**GLENORCHY PLANNING AUTHORITY MEETING
AGENDA
MONDAY, 21 FEBRUARY 2022**

**5. PROPOSED USE AND DEVELOPMENT - MULTIPLE DWELLINGS
(EIGHT PROPOSED) - 21 WINDERMERE BEACH ROAD
CLAREMONT**

Application No.:	PLN-21-494
Applicant:	Longview Design & Drafting
Owner:	C G Priest
Zone:	General Residential
Use Class	Residential
Application Status:	Discretionary
Discretions:	<p>8.4.4 P1 Sunlight to private open space of multiple dwellings</p> <p>C2.6.5 A1.1 Pedestrian Access</p> <p>(The proposal meets all other applicable standards as demonstrated in the attached appendices)</p>
Level 2 Activity?	No
42 Days Expires:	Extension of time granted to 21 Feb 2022
Existing Land Use:	Single Dwelling
Representations:	0
Recommendation:	Approval, subject to conditions

Figure 1: Proposal - Longview Design and Drafting

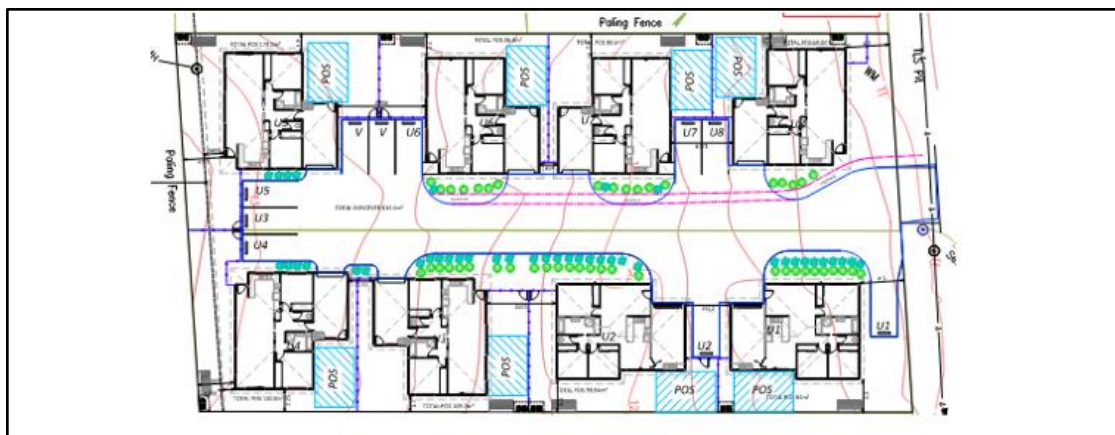
The application is for eight dwellings and demolition of an existing house and shed. The proposed dwellings would be single storey, clad with cement sheet weatherboards and capped with iron, hipped roofs.

The dwellings would accommodate three bedrooms, open plan living and an integrated single garage each.

A central driveway would give access to eighteen car parking spaces, which includes spaces within the garages.

Each dwelling would have private outdoor space of 4m x 6m with a grade no steeper than 1: 10.

The application is discretionary for sunlight to private outdoor space and pedestrian access. The proposal is shown in Figure 1.

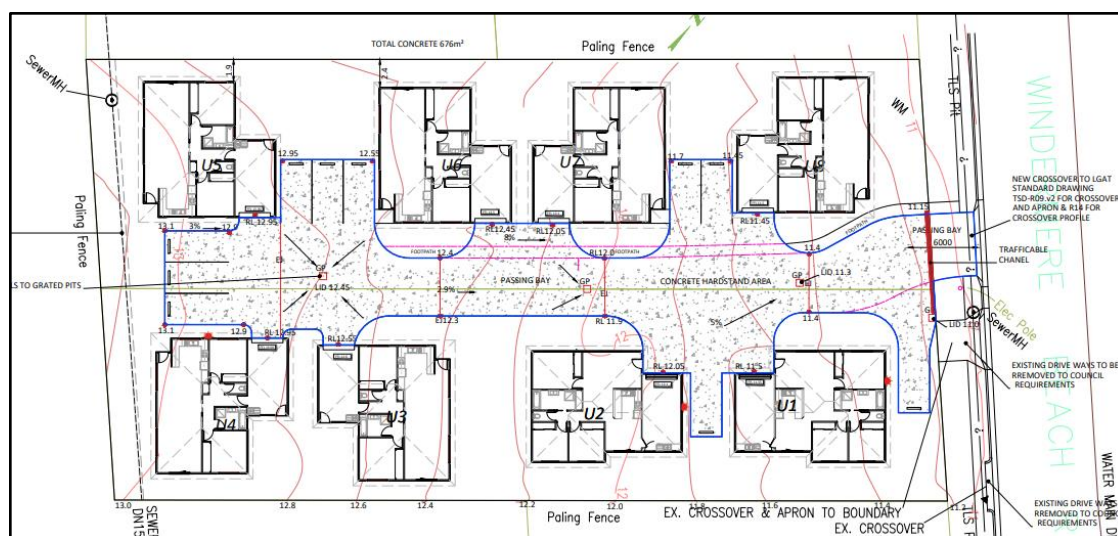
The development application seeks an approval for demolition of the existing structures and construction of eight multiple dwellings at the subject site. The works include reinstating the redundant access and installing a new 5.5m wide access, parking, driveway and stormwater quantity and quality management devices to detain and treat runoff so the post development runoff does not exceed the pre-existing.

The scope of works is shown in the figure below.

The site can be accessed off the proposed 5.5m wide vehicle crossing and the existing access is to be reinstated to the footpath. Therefore, the proposed development complies with the code requirements.

The site can be accessed off the new 5.5m wide vehicular access onto the driveway and parking areas. The sightlines for both directions comply with the Australian Standard.

The turning swept path provided, demonstrate compliance with the standard. The surface treatment of the driveway is proposed to be concrete. Surface runoff is proposed to be captured and directed to the Council's stormwater system.

To comply with the acceptable solution for the pedestrian access requirement, a 1 m wide footpath with 2.5m distance between the edge of the footpath and the access way shall be provided for uses that require 10 or more car parking spaces. The application proposes to provide a 1m footpath within the site but the 2.5m distance does not meet the acceptable solution requirement.

Providing the nature of the use as residential and the frequency of vehicle movements it is considered that the proposed driveway and car parking arrangement are safe and appropriate.
